**Staff Report, Application 241334  
Including Exhibit B, Findings for Denial**

# Staff Report & Development Permit Administrative Use/Site Development Review

Application Number: **241334**  
Applicant: **Cove Britton**  
Site Address: **625 Beach Road, Aptos**

Proposal to construct a two-story, approximately 3,100 square foot detached single-family dwelling pursuant to SB-9, with rooftop decks, attached carport and storage rooms and a pedestrian entrance gate, on a site where one single-family dwelling exists, thereby constituting a two-unit dwelling group; and to construct a second-story, approximately 364 square foot ADU attached to the proposed single-family dwelling. Requires a Minor Coastal Development Permit. Property is located on Beach Drive (625 Beach Drive), approximately one mile southeast of the intersection with Rio del Mar Boulevard.

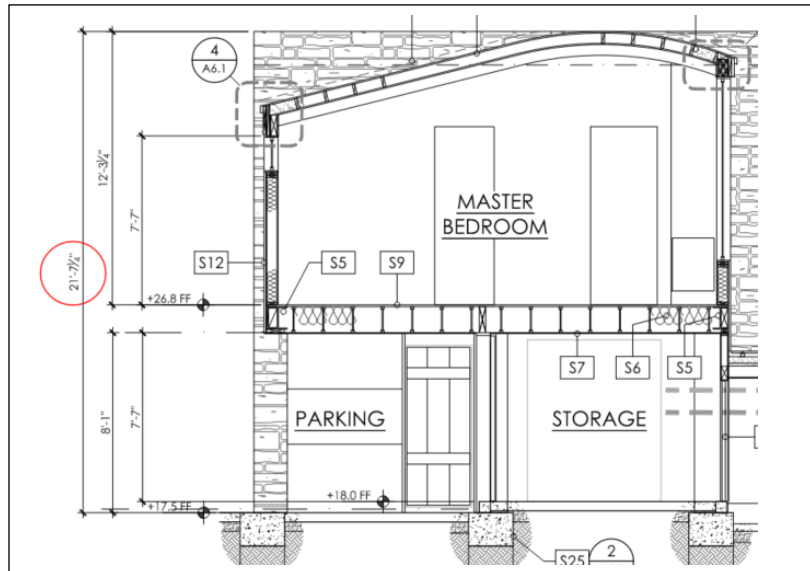
**Height & Stories.** The plans do not comply with SCCC Section 13.10.323(C) (Development Standards in Residential Districts), which provides that the maximum height for any structure on

beach lots of Beach Drive in the RB district is 17 feet and maximum number of stories is one. The proposed structure would be more than 21 feet and two stories, as indicated below.

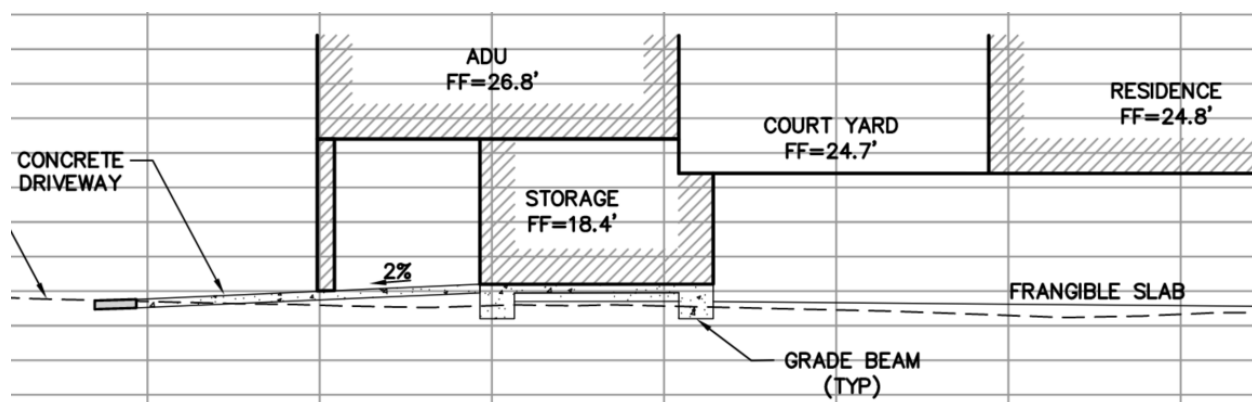
While the applicant maintains that the entire ground-level of the proposed structure is “underfloor,” and therefore does not count as a story, this interpretation is inconsistent with the SCCC. “Underfloor” is defined by SCCC 13.10.700-U as: “a non-habitable space between the underside of the first story floor framing (joists or girders that directly support the floor sheathing) and the grade below. An underfloor is not considered a ‘story’ (see definition). To qualify as underfloor, the space may be used for storage but cannot have a finished floor, insulation, or conditioned space, and there must be no stairway access to the underfloor area.” The frangible (breakaway) slab underlying part of the structure is functionally equivalent to “the grade below,” and so is considered underfloor. However, the carport and storage areas have finished floors (FF = 18.4’) and are therefore considered a story.

Two rooftop decks are proposed, one above underfloor and one above the first story comprised of carports and storage. The latter deck is therefore a second-story rooftop deck, which is prohibited by SCCC 13.10.323(F)(1), which states in part, “Second story rooftop decks and landings are not permitted.
